#### PLANNING APPROVAL STAFF REPORT Date: June 15, 2006

**NAME** Over Flow Ministries, Inc. (Wilbert Hardy, Pastor)

**LOCATION** 1201 North Drive

**CONTEMPLATED USE** Planning Approval to allow a church with child day care

## SITE PLAN

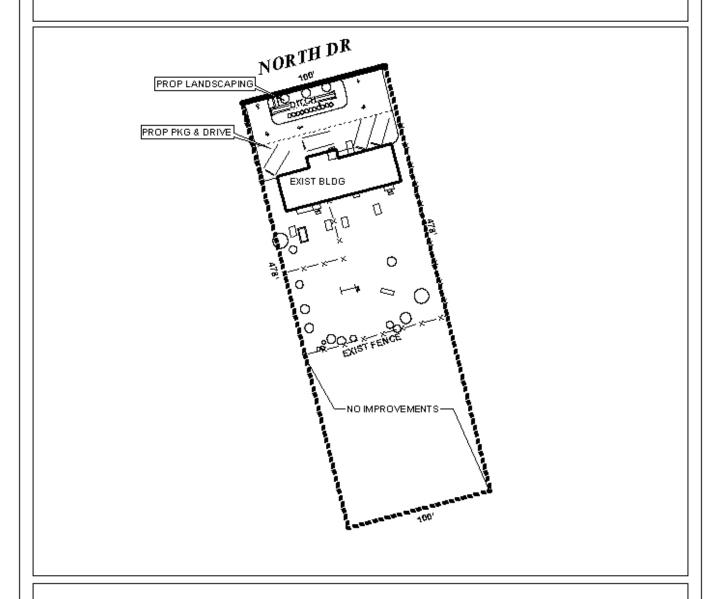
The applicant has submitted a revised site plan depicting a total of four (4) parking spaces in the existing paved area, with one-way circulation, and proposed landscaping for the public right-of-way. The applicant has also provided a floor plan for the existing building, depicting a total of twelve (12) seats within the church sanctuary: the applicant was advised of the parking ratio of one space per 4 pew seats, hence the provision of the floor plan for the building.

<u>Traffic Engineering Comments:</u> Driveway number, size, location, and design to be approved by Traffic Engineering and conform to AASHTO standards. The south driveway should be narrowed for one-way traffic flow. As shown it is wide enough for two-way traffic and may encourage traffic flow in the wrong direction. As shown the parking stalls do not meet the minimum standards to allow cars to properly maneuver out of the stall and through the parking lot. Changes should be made to the parking layout to meet minimum standards.

It should be pointed out that the right-of-way width for North Drive is 80-feet, which exceeds the minimum requirement of 60-feet for roads lacking curb and gutter. It is possible that some of the right-of-way for North Drive could be vacated by the City and returned to the site in question. Furthermore, the unopened right-of-way immediately East of the site could be vacated by the City and used to increase the width of the site in question, should future expansion be desired. It should be noted, however, that the applicant is responsible for initiating the street vacation process, and that any changes to the site plan or scope of operation of the church facility will require a new Planning Approval application.

Finally, the provision of landscaping should be coordinated with Urban Forestry to ensure compliance with the Zoning Ordinance.

**RECOMMENDATION** Planning Approval: Based upon the preceding, the request is recommended for Approval, subject to the following conditions: 1) improvements to and use of the site are limited to the revised site plan and floor plan as submitted; 2) any expansion of the use (such as an increase in the size of the congregation) or modification to the site, including the provision of additional parking, will require full compliance with the Zoning Ordinance, including parking that fully meets the standards within the Ordinance, and will require a new application for Planning Approval; 3) coordination with Urban Forestry to ensure compliance with the tree and landscaping requirements of the Zoning Ordinance; and 4) full compliance with all other municipal codes and ordinances.
